**REPLACEMENT OF BLUE RIDGE PARKWAY
BRIDGE OVER INTERSTATE 26**

**Federal Project Number– NC_ST_BLRI_I26_NEPA
PMIS 221876**

**Value Analysis (VA) and Choosing-by-
Advantages (CBA) Study**

August 2016

APPENDIX D: MOUNTAIN-TO-SEA TRAIL PRELIMINARY RELOCATION PLAN

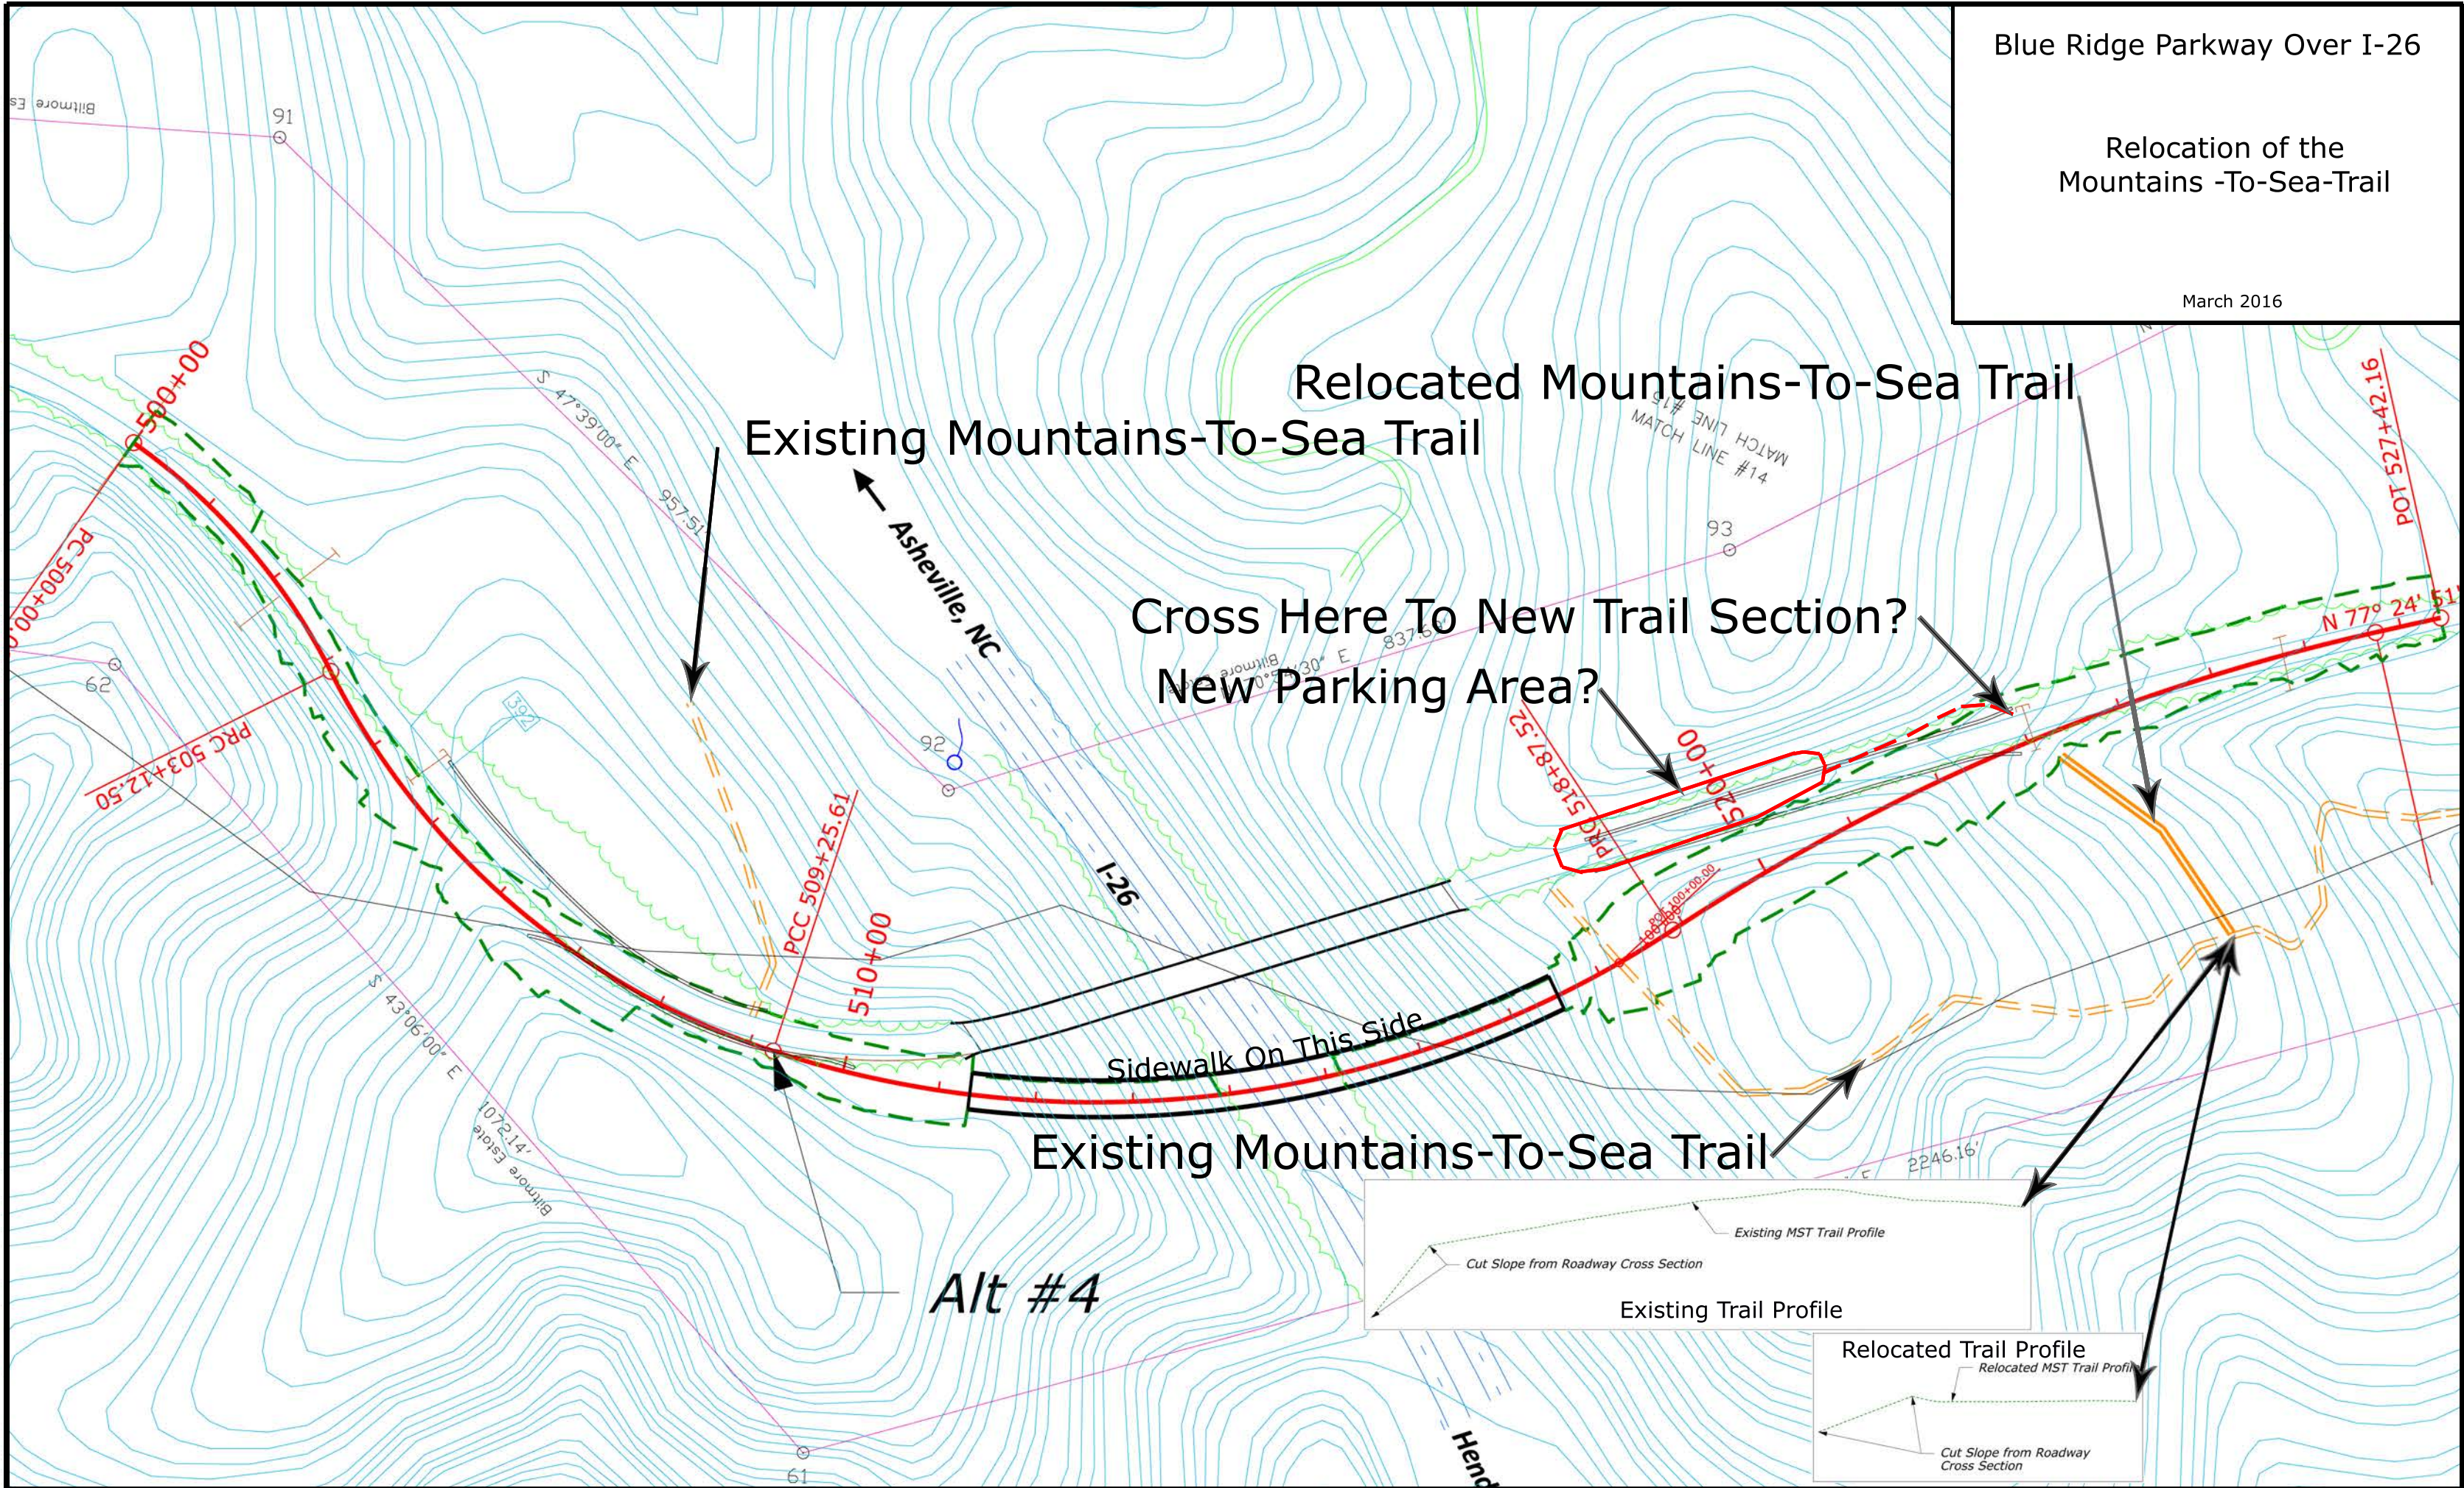
Design recommendation - Consider ways to realign the trail to Parkway left at MP 392. This would avoid the need for a pedestrian road crossing at or under the bridge to access the sidewalk (i.e. the trail would be on the same side of the bridge at both the west and east ends of the bridge). A preliminary relocation plan in the project vicinity is presented in Appendix D.
